SERVICE INFORMATION LETTER SI 01.02

Machines/Models: WIDE SERIES X MODEL **Serial Numbers:** Above 6012

PURPOSE: Inspect the Pivot Bolt in the Brake Linkage.

Figure 1

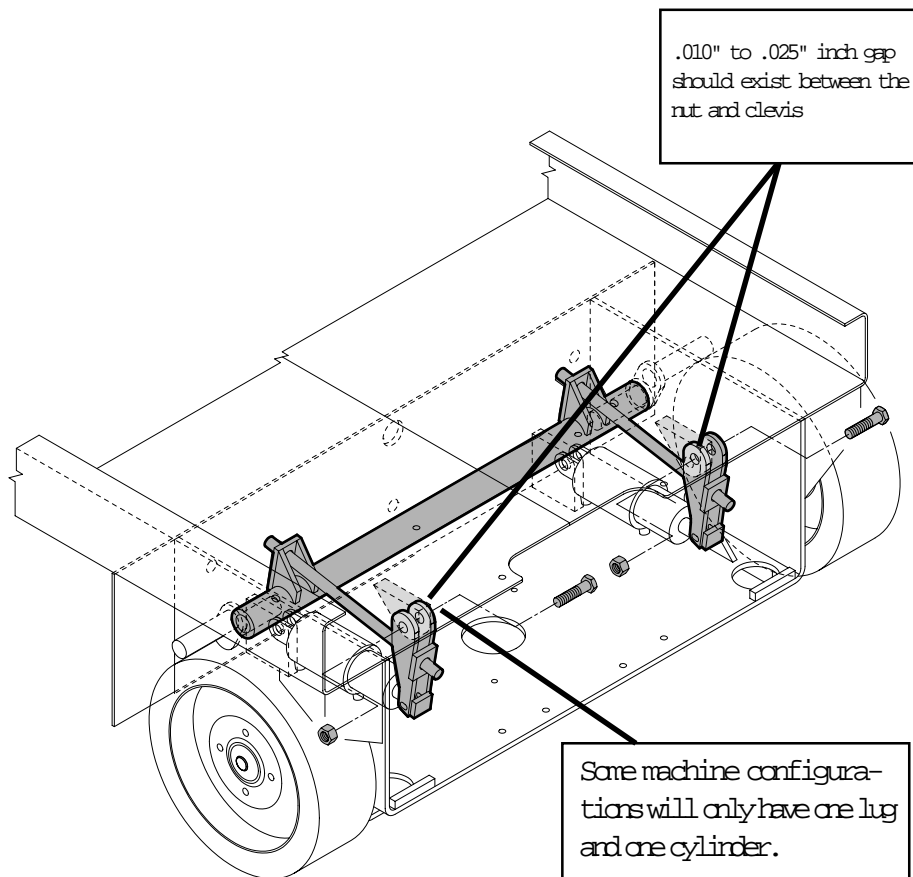
1. The 3/4" bolt in Figure 1 should not be torqued, verify that a gap of .010 to .025" exists between the nut and the side of the brake adjustment weldment.
